<u>M E M O R A N D U M</u>

SUBJECT: REVIEW COMMENTS - STONEY RIDGE FARM BED & BREAKFAST ESTATE

CONDITIONAL USE APPLICATION

3.B Existing Condition

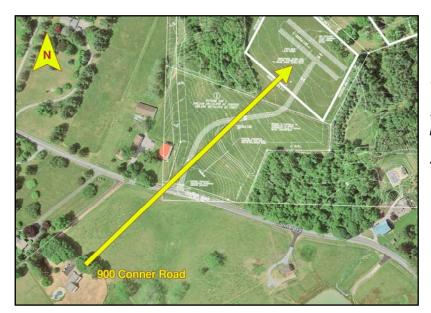
Topographic differences and existing vegetation to be preserved will supply the required Perimeter Buffer for the abutting Single-Family residences, and along Copeland School Road. In particular, the areas indicated by Mr. Comerford during our site visit as the <u>likely</u> locations for the placement of an event tent are not visible from off-site.

Tenting location(s) shall be established during the Conditional Use review process.
